Millstone Nuclear Power Station, Unit No. 3
Transmittal of Responses to Requests of Additional
Information and Draft SER Open Items (Geotechnical Issues)

RESPONSE OR SCHEDULE FOR
SUBMITTAL OF RESPONSE
TO GEOTECHNICAL MEETING ACTION ITEMS
(241 SERIES QUESTIONS)

SUBJECT: Meeting Summary - February 14, 1984
Discussion of 241 series Questions and
Draft SER Geotechnical Open Items

RESPONSE TO REQUESTS FOR
ADDITIONAL INFORMATION
ACTION ITEMS RESULTING FROM FEBRUARY 14th MEETING

FIGURE Q241.22-2
WEST RETAINING WALL DETAILS
MILLSTONE NUCLEAR POWER STATION
UNIT 3
FINAL SAFETY ANALYSIS REPORT

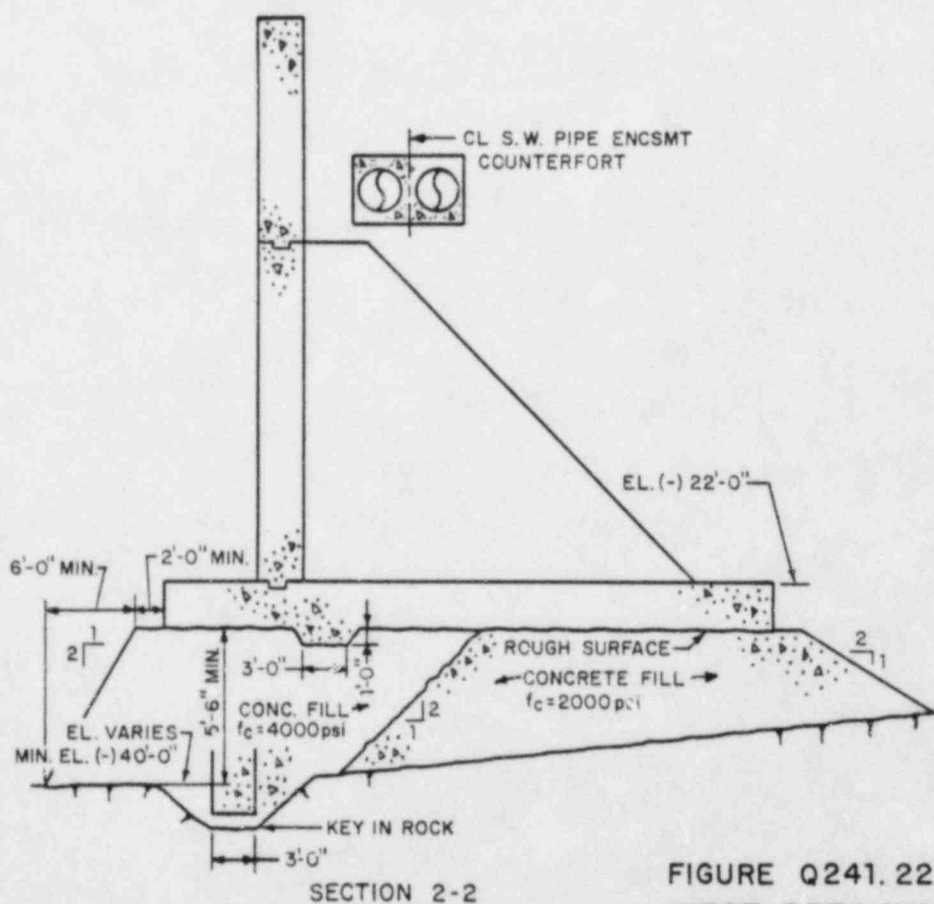
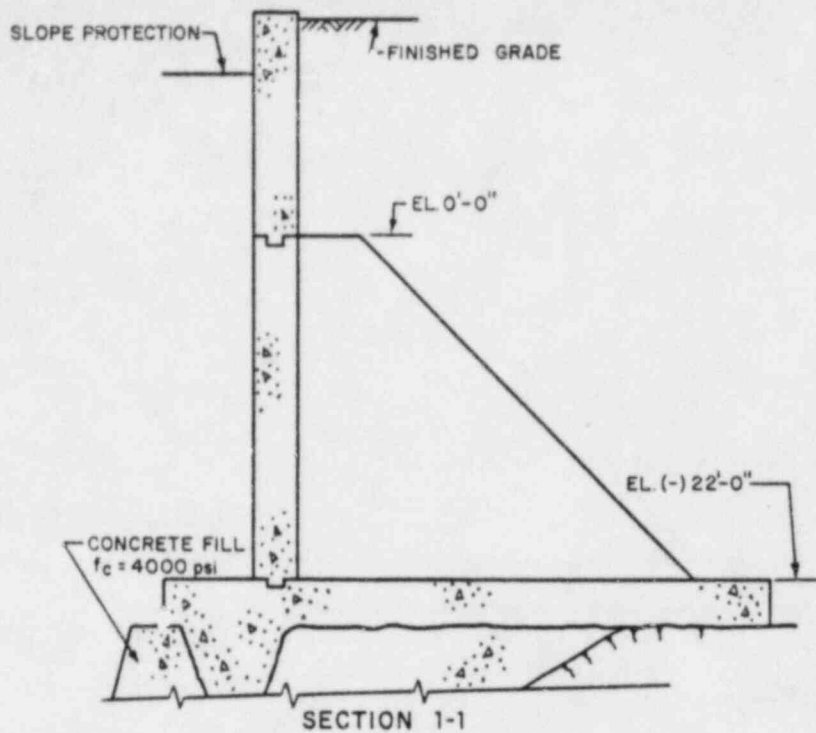
- b) Mr. Chen would like to see sections and plans of retaining¹ wall (Cat. I).

Figure Q241.22-1 provides a plan view of the west retaining wall. Figures Q241.22-2 and -3 provide sections of the west retaining wall.
